## **Auto Feed Stud Gun for Insulation Pins**

# **National Shipbuilding Research Project #7-96-7**

## **Milestone #12 Final Report**

Prepared by  
William C. Easterday  
TRW Nelson Stud Welding Division  
7900 West Ridge Road  
Elyria, OH 44036-2019

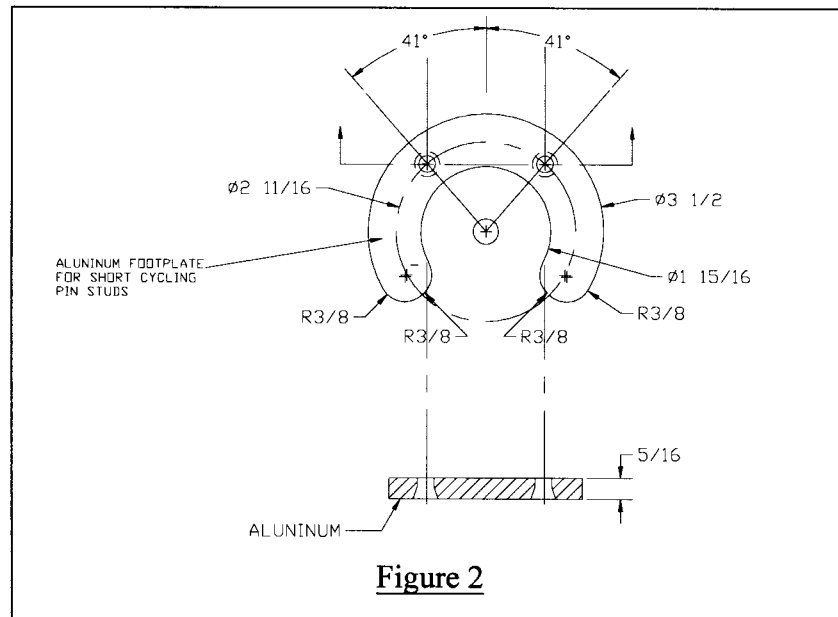
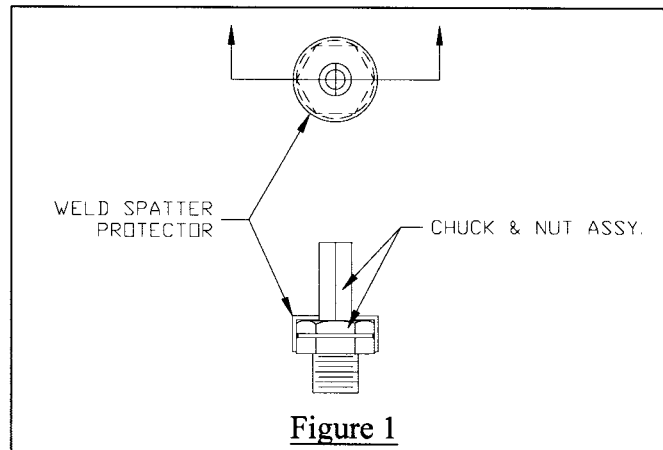
C.1.8.1. Newport News indicated that weld spatter buildup may be a problem particularly when welding short studs overhead. Use of an open horseshoe shaped foot plate, larger diameter spark shield, and/or spatter protection for the stud feeding mechanism were suggested. This foot plate approach may also reduce operator fatigue when welding overhead by simplifying the task of maintaining the stud perpendicular to the work surface. Refer to figures 1 and 2.

C.1.8.2. Bath Iron Works also expressed a concern about spatter buildup and erosion of the spark shield. The solution proposed by BIW is a copper or copper alloy outer tube with a ceramic liner. This is a spark shield design similar to those used by Nelson Stud Welding systems when applying the studs used for boiler relining in the electric utility industry.

D.1.8.1. The proposal holding the most promise for reduction of spatter buildup, simplicity in maintaining stud perpendicularity, and light weight was the open "horseshoe" foot suggested by Newport News Shipbuilding. The NNS design was adapted to fit the leg and chuck spacing of the standard Nelson stud welding gun.

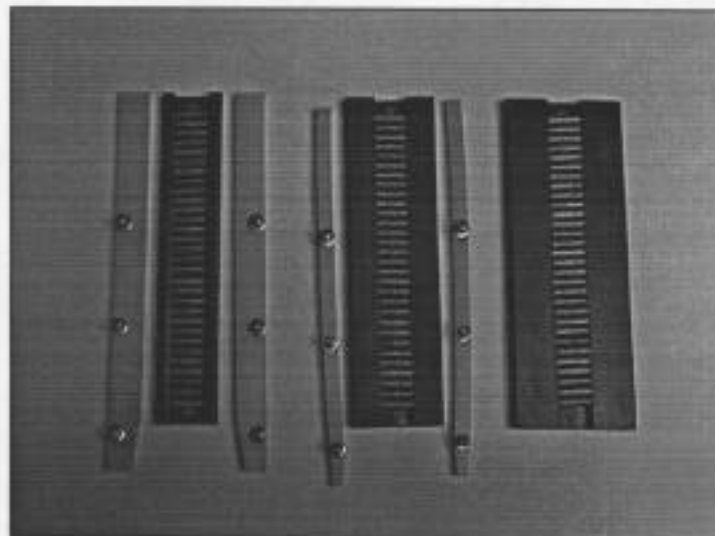
C.4.1.1. The use of relatively small hardware for mounting the interchangeable aperture plates and magazine spacers in a shipyard environment was felt to be a potential problem by Newport News Shipbuilding, Bath Iron Works, and Electric Boat Corporation.

C.4.1.1.1. NNS recommended that the aperture plates, spacers, and their mounting hardware be incorporated into an interchangeable magazine design.

C.4.1.1.2. BIW suggested that a method of inserting cartridges for the shorter studs inside of cartridges for longer studs be developed.

C.4.1.1.3. Electric Boat suggested that all cartridges have the same external dimensions to eliminate the need for removable spacers in the magazine and their associated mounting hardware. These spacers were used to take up the extra space in the magazine when studs shorter than the longest 1.94" ones are used.

- D.4.1.1. The cartridges for the .94" and 1.44" long studs were redesigned to have the same outside dimensions as those for 1.94" long studs. This eliminated the need for the nylon filler bars used to take up the excess space in the magazine housing. It also eliminated the small screws formerly used to retain these spacers in the magazine housing.

- D.4.1.2. The aperture plate and its retention method were redesigned to eliminate the need for removing screws when changing aperture plates as dictated by a change in stud length. This was accomplished by extending slots to the edge of a newly designed removable aperture plate keeper. It is only necessary to loosen the screws a turn or so to allow removing the aperture plate keeper and provide access to the aperture plate for removal.

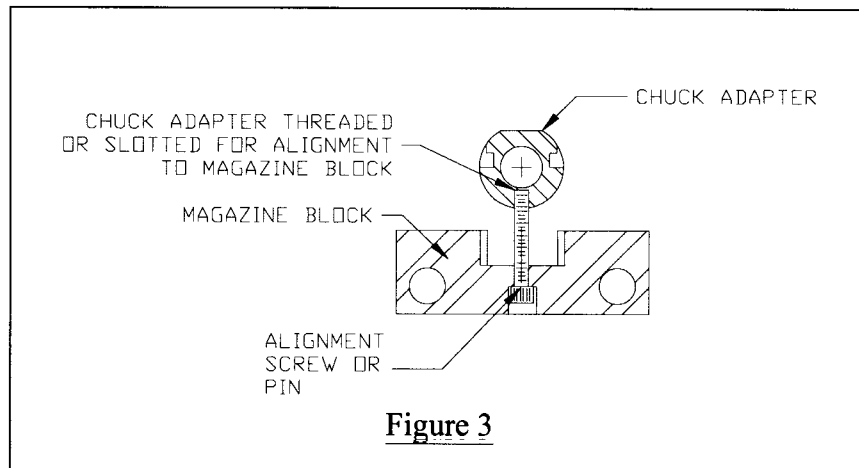
C.4.1.3. Newport News suggested the use of a screw or pin as a chuck adaptor alignment aid during stud size change over. See figure 3.

- D.4.1.5. The ease of alignment of the new aperture plates with the magazine housing assembly and the addition of a chamfered opening in the bottom of the chuck adaptor precluded the need for the alignment aid and pinning suggested by two test sites and described at C.4.1.3 and C.4.1.4 above.
